Location of Construction: 243 Congress St		Owner:		Phone:	
Owner Address:		Leasee/Buyer's Name:		Business Name:	
Contractor Name:		Address: 400 ...		Phone: ...	
Past Use:		Proposed Use:		COST OF WORK: \$ 24,000.00 PERMIT FEE: \$ 100.00	
		FIRE DEPT. <input type="checkbox"/> Approved <input type="checkbox"/> Denied		INSPECTION: Use Group: Type:	
Proposed Project Description:		Signature:		Signature:	
		PEDESTRIAN ACTIVITIES DISTRICT (P.U.D.) Action: <input type="checkbox"/> Approved <input type="checkbox"/> Approved with Conditions <input type="checkbox"/> Denied		Signature: _____ Date: _____

APPLICATION FOR AMENDMENT TO PERMIT

REASON FOR PERMIT: Reversing floor plan - adding a chimney

DATE: 31 Dec, 97 ADDRESS: 243 Ray ST.
REASON FOR PERMIT: Amendment To permit - Add Chimneys
BUILDING OWNER: MJM ASSOCIATES
CONTRACTOR: ↓
PERMIT APPLICANT: ↑ APPROVAL: *2, *3, *6, *8, *10 ~~DENIED~~
USE GROUP R-3 BOCA 1996 CONSTRUCTION TYPE 513

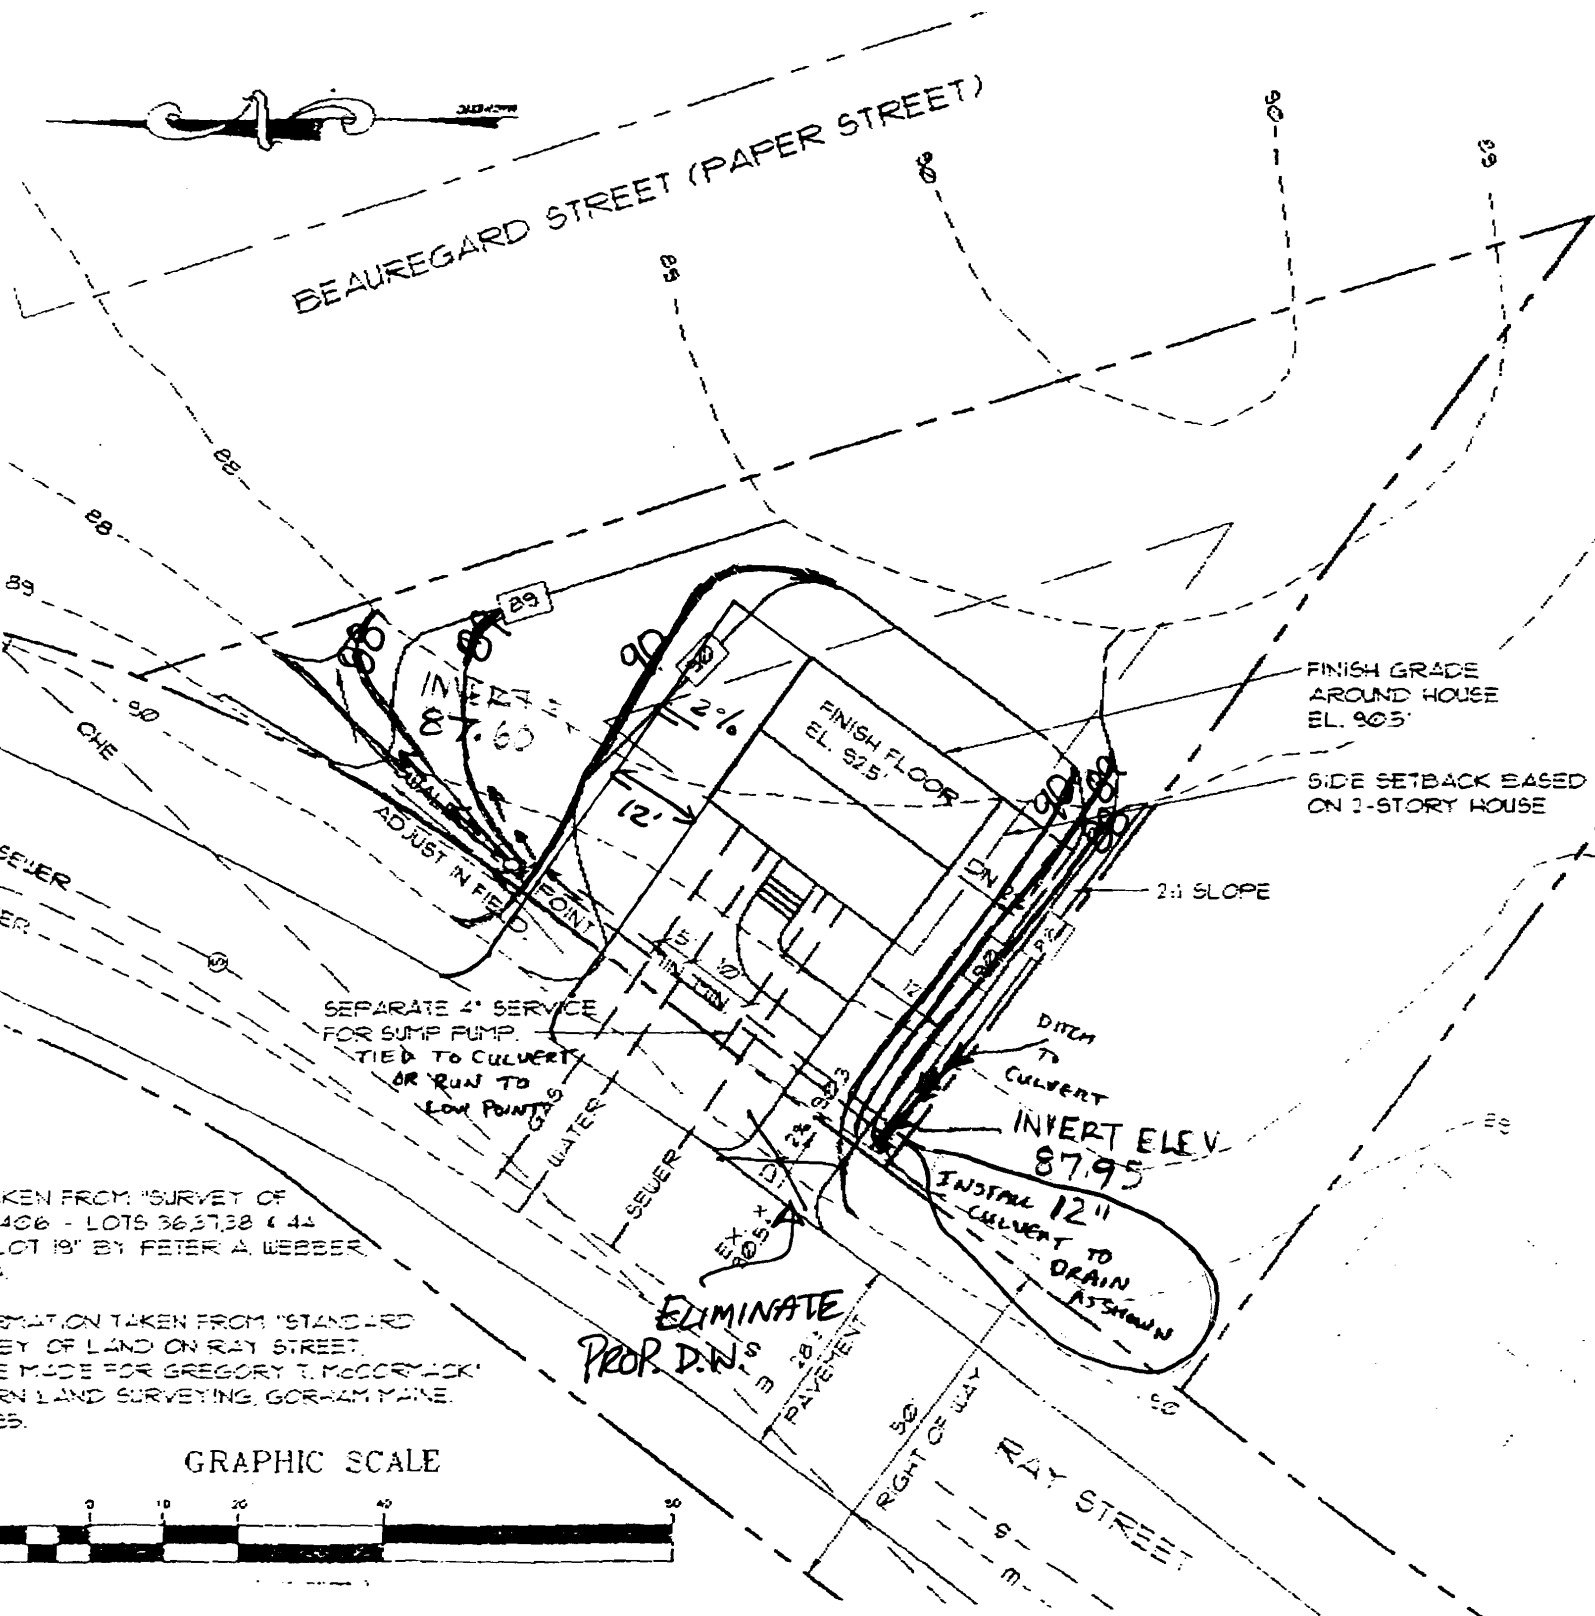
SEPARATE 4" SERVICE FOR SUMP PUMP TIED TO CULVERT OR RUN TO LOW POINTS

DITCH TO CULVERT
INVERT ELEV 87.95
INSTALL 12" CULVERT TO DRAIN ASSIGNED

ELIMINATE PROP. D.W.
